IMPORTANT PARTS-SERVICE COMMUNICATION

NO: CAG-432

SUBJECT: New Direct Spark Igniters for PGA, PGB and PGD Gas/Electric Package Units

**Location of new Direct Spark Igniter
Amana Part # 20261708**

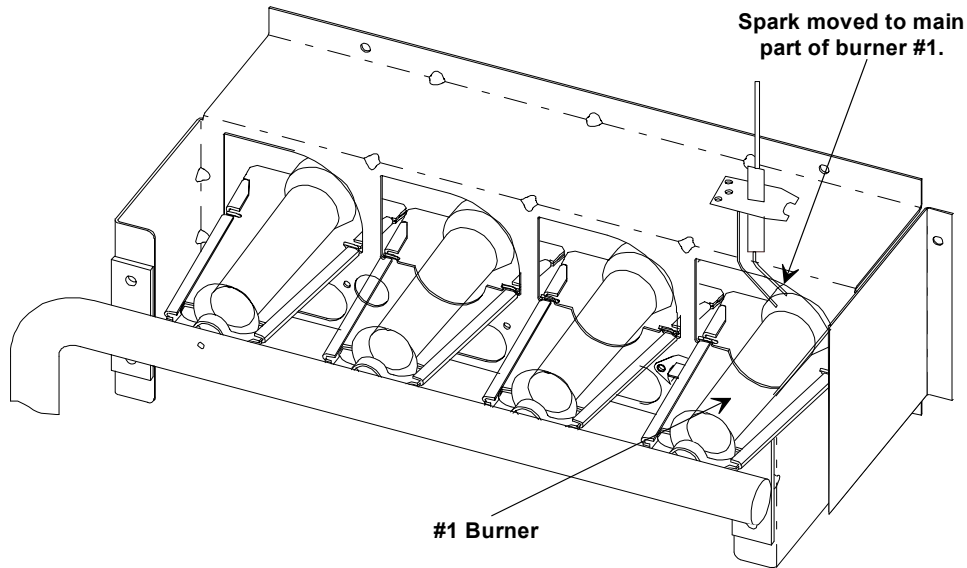
Amana has received field reports indicating that the new PGA*C*2E/F, PGB and PGD*C*2E model gas/electric package units may not light properly after having been converted to Propane Gas. This issue affects units built at the end of February 2001 through the end of May 2002 (Serial date codes 0102 through 0205). These units were built using the same burner bracket as used on our current 40" 90% furnaces. This change to the new burner bracket commonized the burner components and reduced the number of service parts required in the field. To address this issue Amana has released a new direct spark igniter (Amana Part # 20261708).

If after all the above mentioned items (1-4) have been checked and the unit is still not lighting on Propane Gas, the next thing to do would be to replace the direct spark igniter (Amana Part # 20261706 or 07) with the new direct spark igniter (Amana Part # 20261708). This new direct spark igniter places the spark in the main burner stream of burner #1 whereas the previous igniters placed the spark at the crossover between the first and second burner (refer to the figure below).

PGA, PGB and PGD*C*2E/F gas/electric package units manufactured beginning later part of May 2002 (Serial date code 0205 and later) will incorporate the new direct spark igniter (Amana Part # 20261708).
